**Moorhead Area Public Schools
New Elementary School
Moorhead, Minnesota**

Project No. 15-025

ADDENDUM No. 1

CMU WALL PATTERN TYPE& DRYWALL ELEVATION

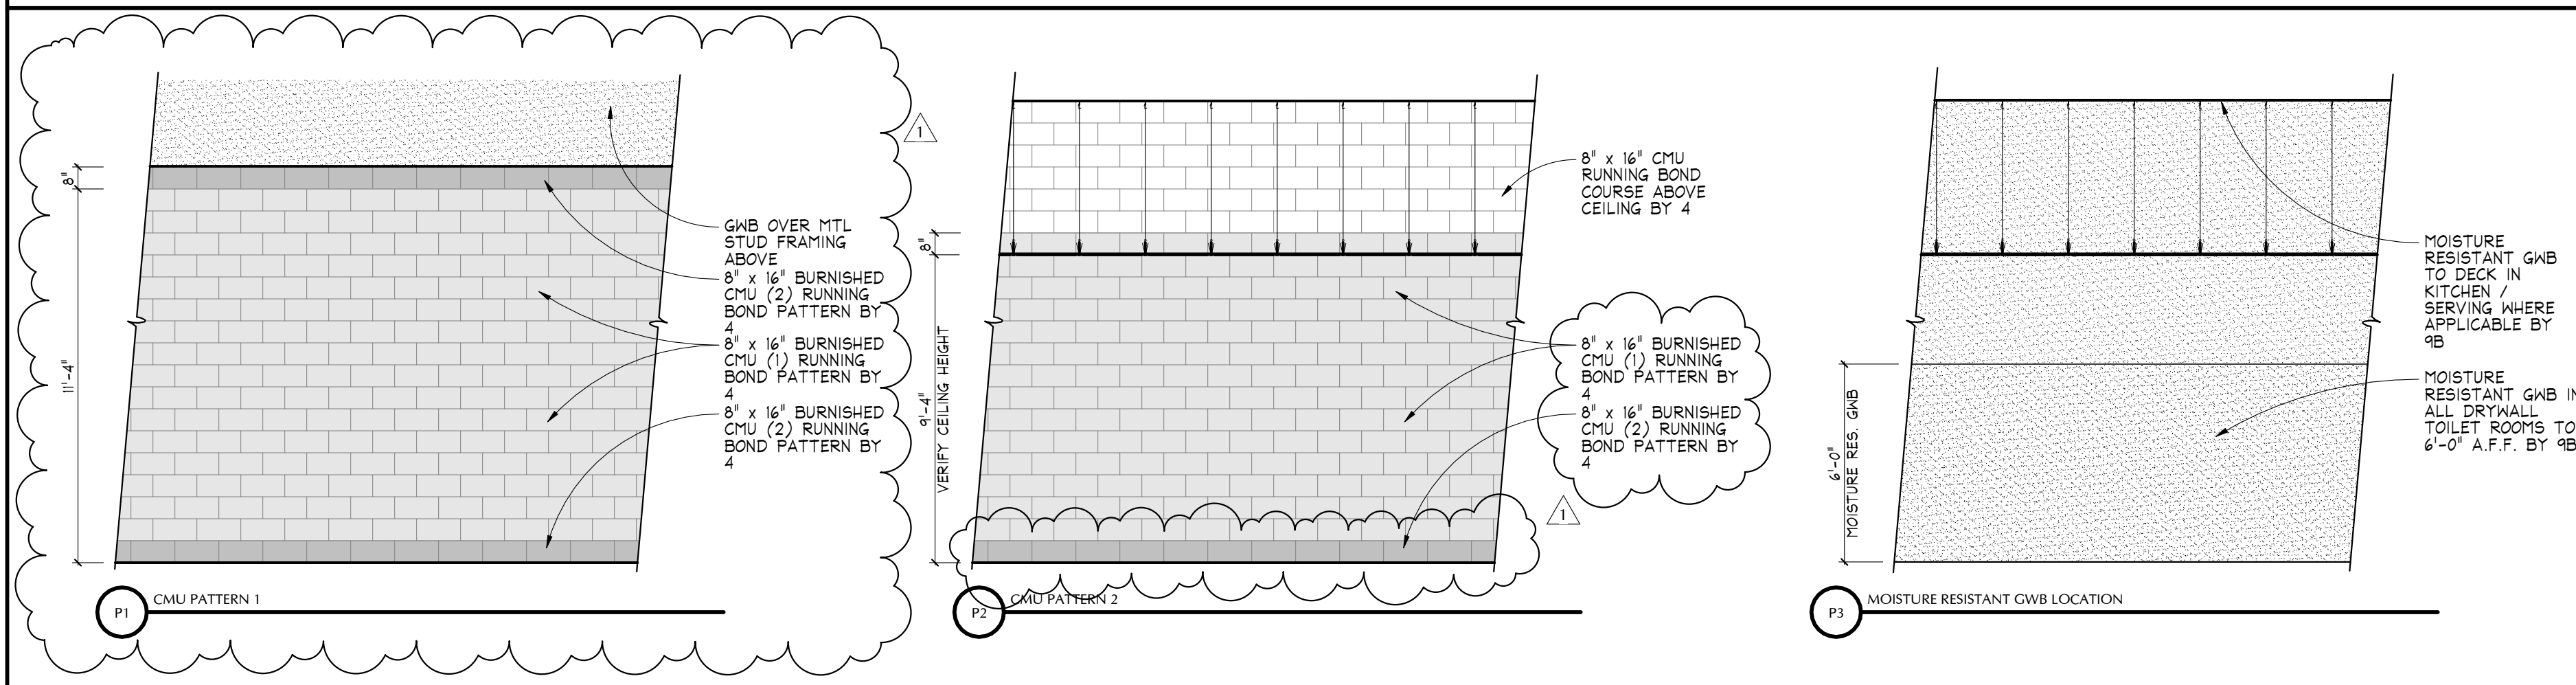
1. CMU Wall Pattern Types & Drywall Elevation:
 - a. Replace with attached revised wall patterns.

1 AREA A ENLARGED PLAN
SCALE: 1/8" = 1'-0"

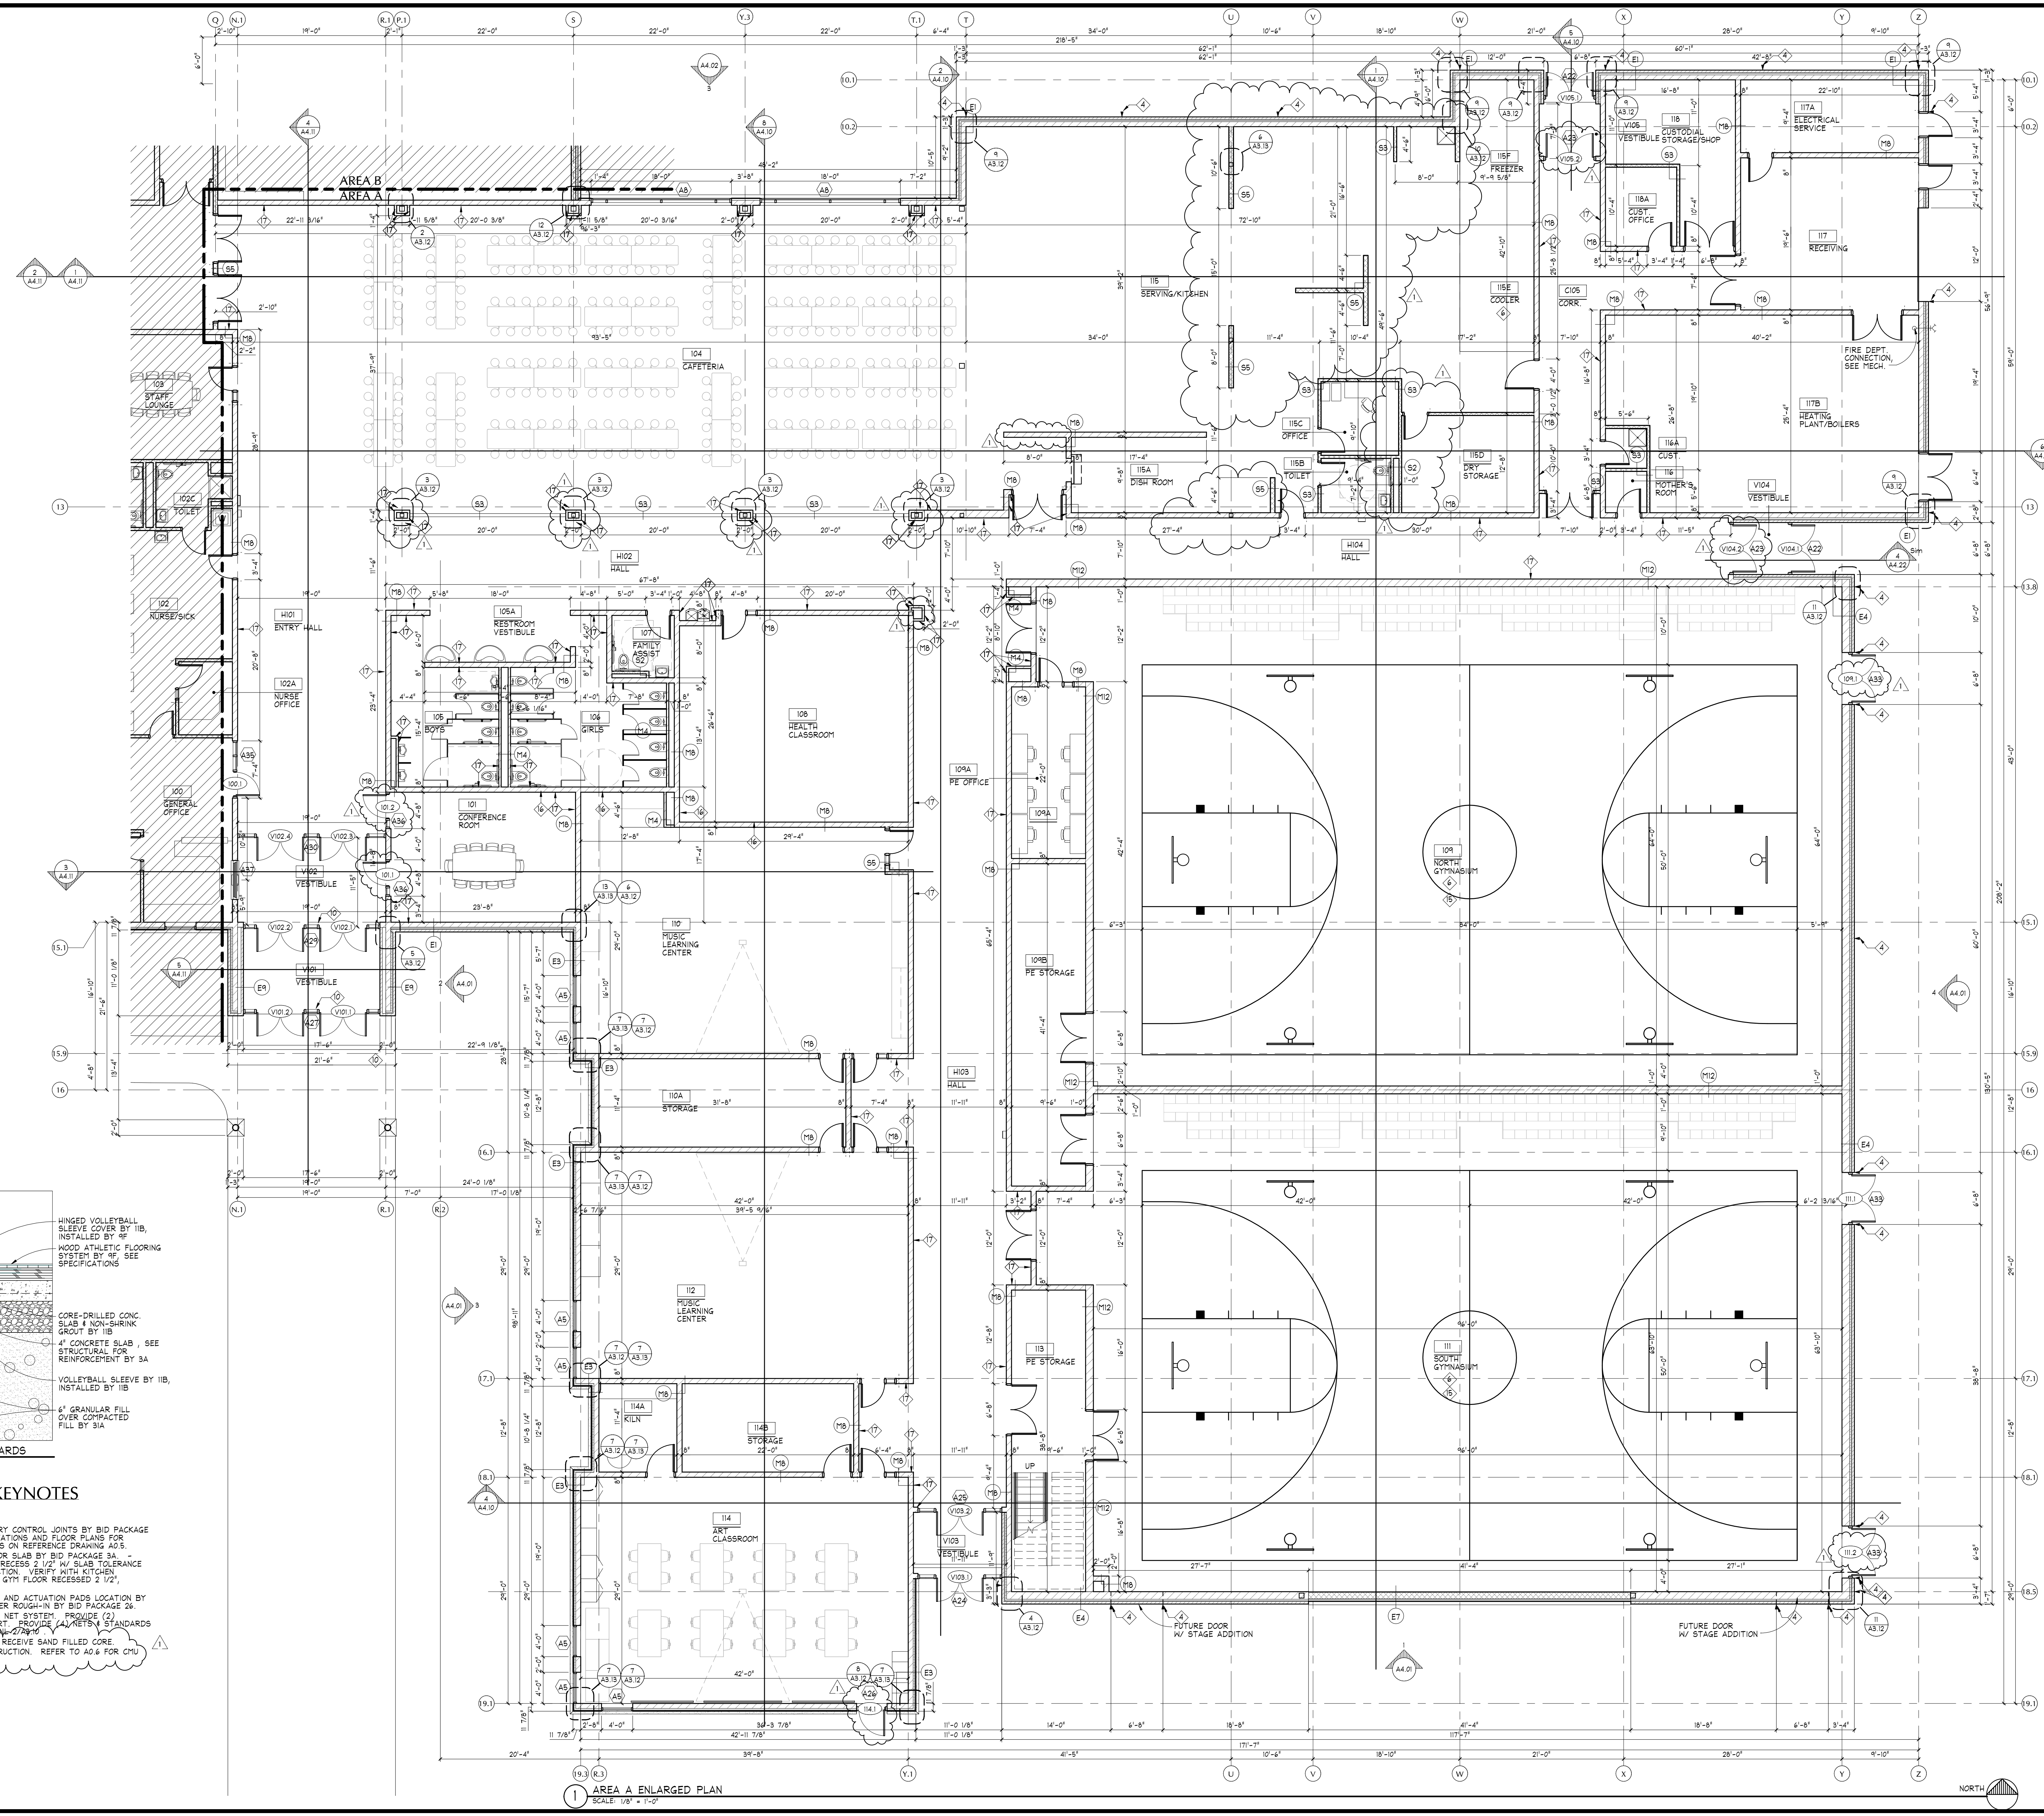
1. Area A Enlarged Plan:
 - a. Revise column wraps on grids P.1, S, Y.3, T.1 at the south of Cafeteria 104 to indicate wall type M4, see attached revised plan.
 - b. Add plumbing chase wall to east wall of Toilet 115B, see attached revised plan.
 - c. Revise Dry Storage 115D and Dish Room 115A as indicated on attached revised plan.
 - d. Revise Serving/Kitchen 115 as indicated on attached revised plan.
 - e. See attached revised plan for additional aluminum frame and door tags.

1 AREA B ENLARGED PLAN
SCALE: 1/8" = 1'-0"

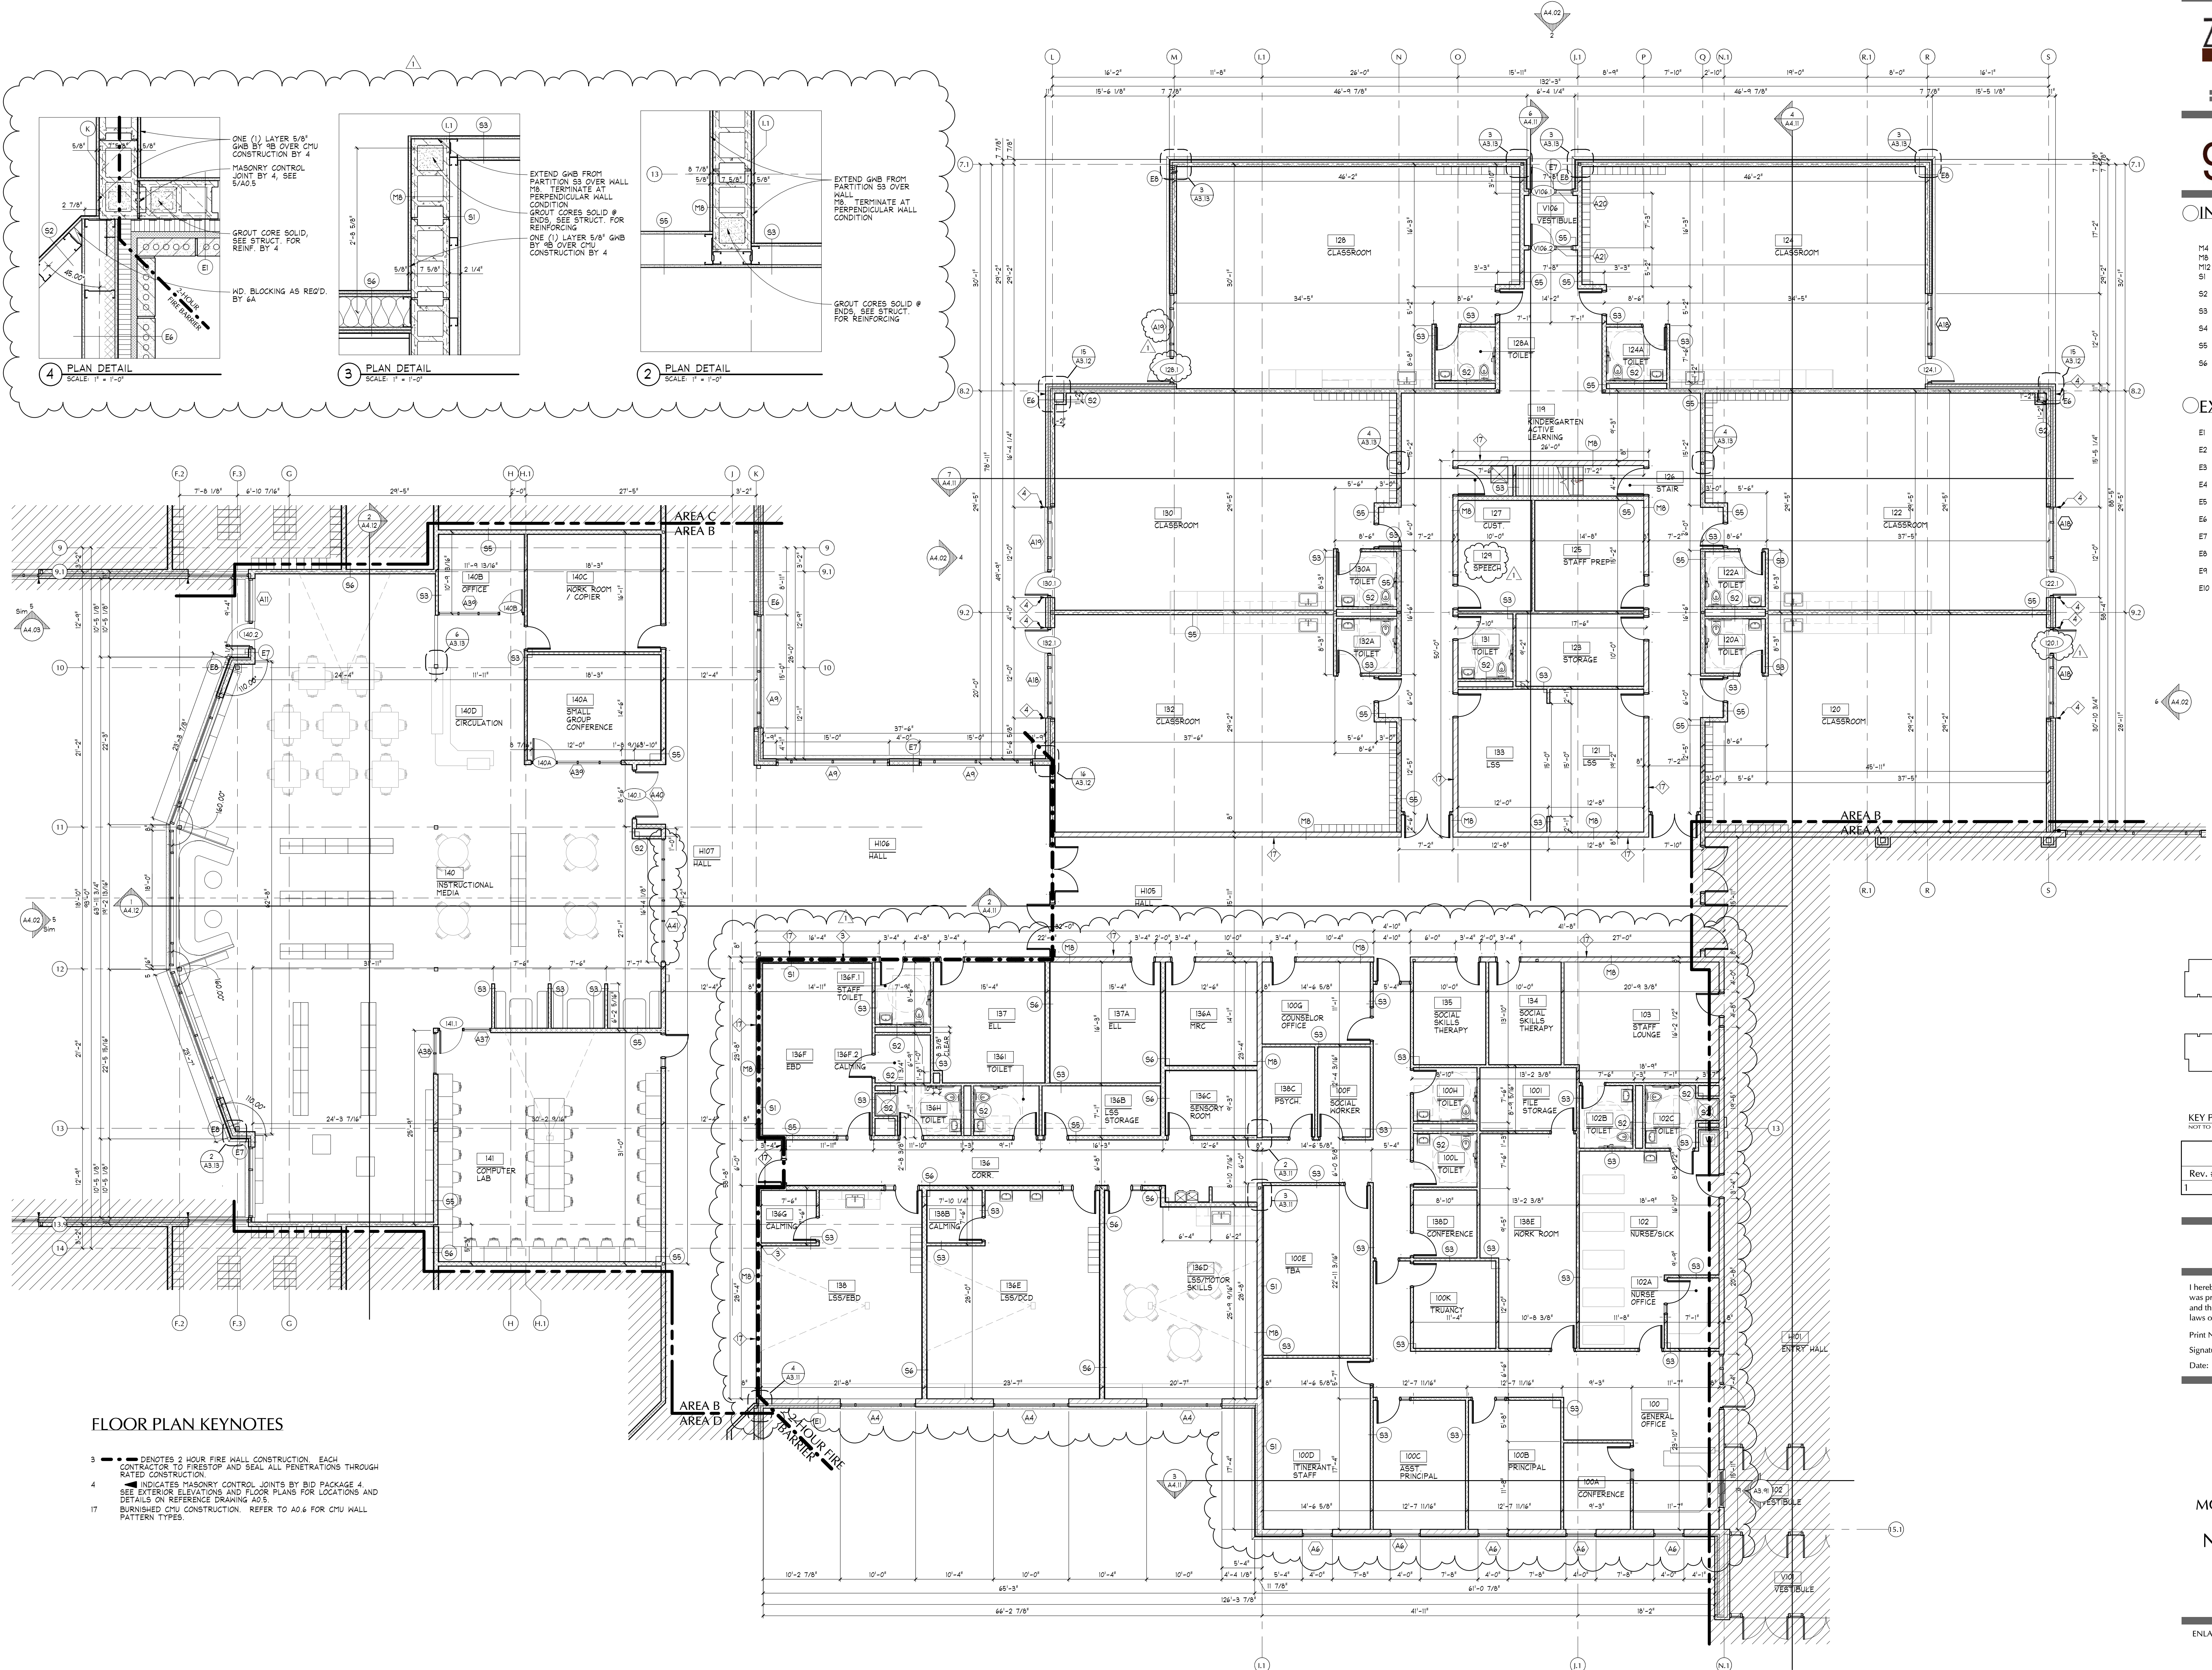
1. Area B Enlarged Plan:
 - a. Replace with attached revised area B enlarged plan.
2. Insert attached plan details 2, 3 and 4/A3.11.
3. Revise LSS 129 to Speech 129.
